## **Final Environmental Impact Statement**

### **Big Creek No. 4 Project California**

**(FERC Project No. 2017)**

RELICENSING THE BIG CREEK No. 4 HYDROELECTRIC PROJECT  
IN THE SAN JOAQUIN RIVER BASIN

Figure 3. Schematic of Edison's Big Creek System (Source: Edison, 1997, as modified by staff).

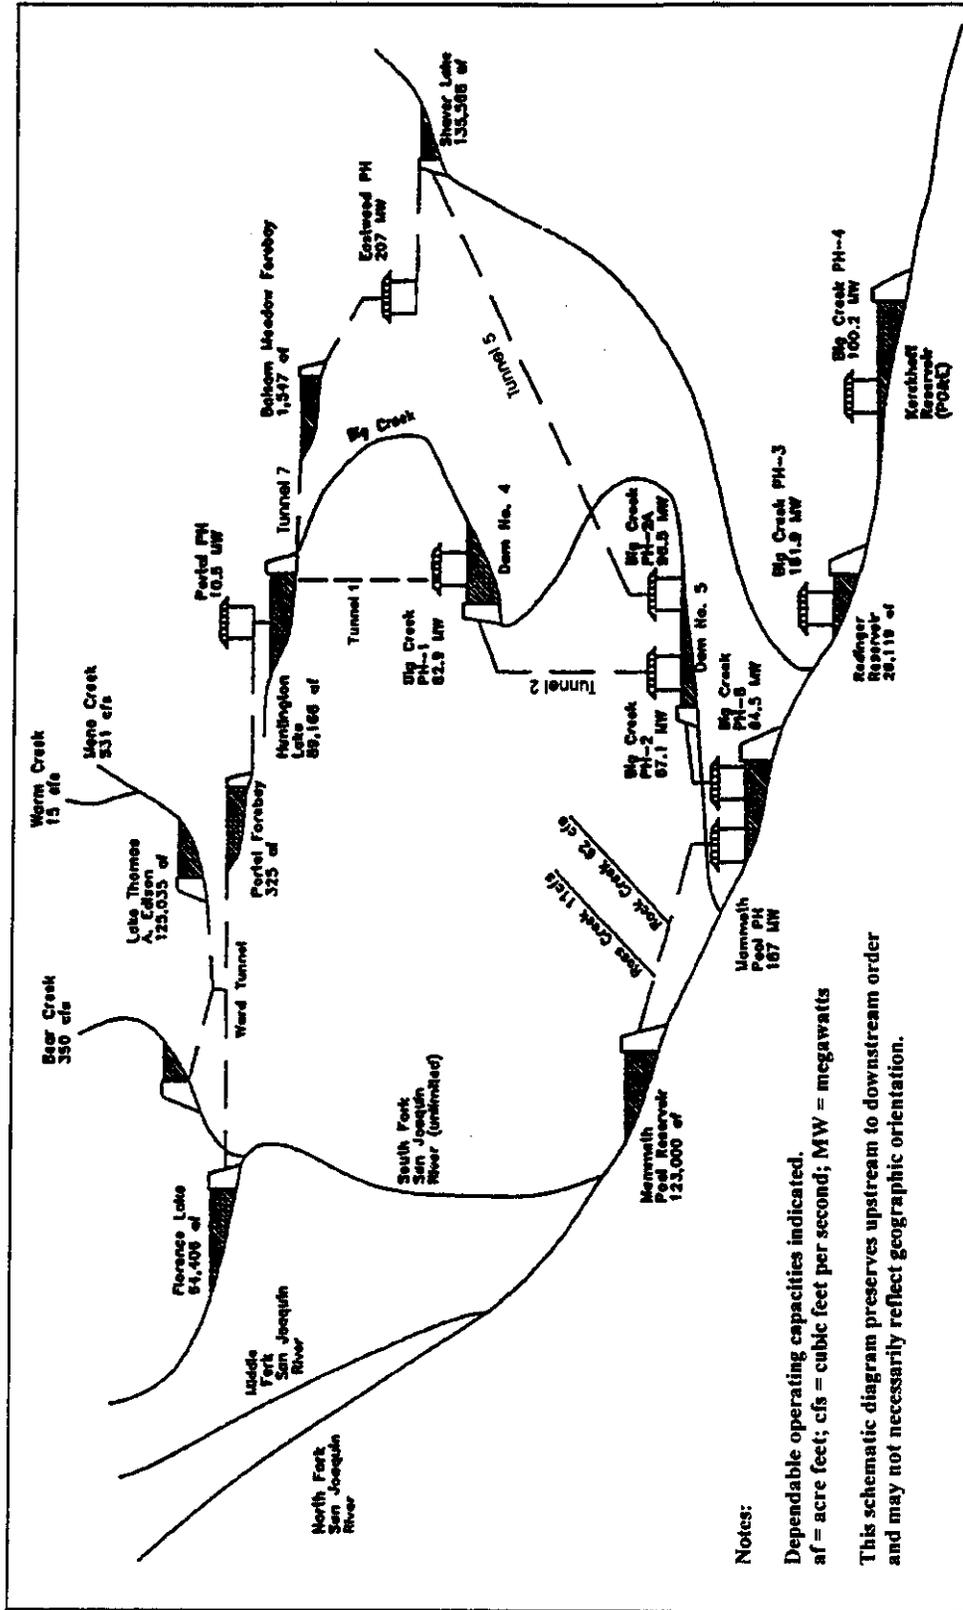
**Comment:** The FS comments that figure 3 in the draft EIS is somewhat confusing. Edison notes that we should add Tunnel No. 1 between Huntington Lake and the Big Creek No. 1 powerhouse to the figure.
